SERVICE BULLETIN

CHECKING OR REPLACEMENT OF OIL FILTER FOR ROTAX® ENGINE TYPE 912 AND 914 (SERIES)

SB-912-017 UL R1

SB-914-037 UL

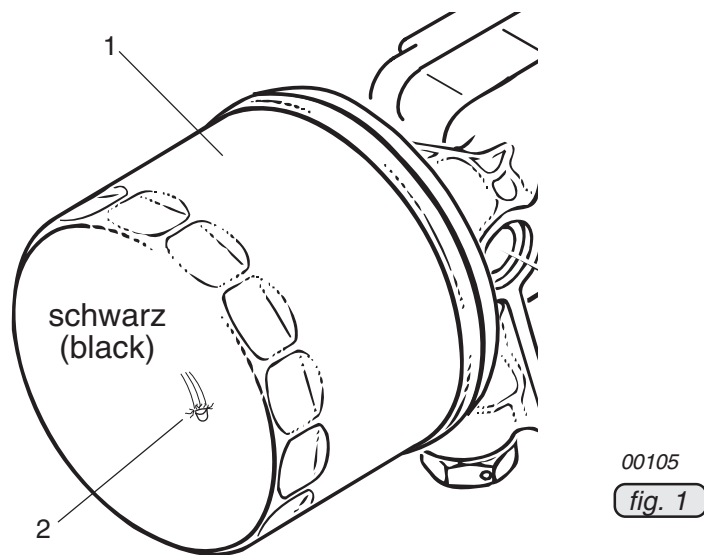
Under certain unfavourable conditions, which may be caused by vibrations and oscillation, certain filter designs may malfunction due to the design of the internal spring which could wear through the filter shell.

(see fig. 1)

Check crown of filter for physical damage and possible bulging (2) caused by the inner spring (inherent on some filter designs).

Fig.no.	New p/n	Qty/engine	Description	Old p/n	Application
(1)	825703	1	oil filter	825700	oil circuit

fig. 1

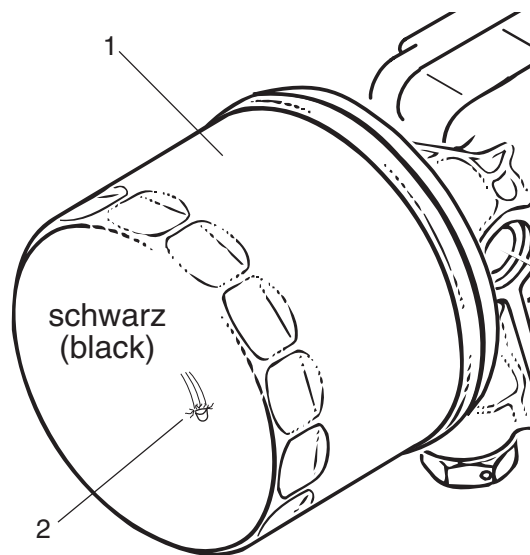
Under certain unfavourable conditions, which may be caused by vibrations and oscillation, certain filter designs may malfunction due to the design of the internal spring which could wear through the filter shell.

(see fig. 1)

Check crown of filter for physical damage and possible bulging (2) caused by the inner spring (inherent on some filter designs).

Fig.no.	New p/n	Qty/engine	Description	Old p/n	Application
(1)	825703	1	oil filter	825700	oil circuit
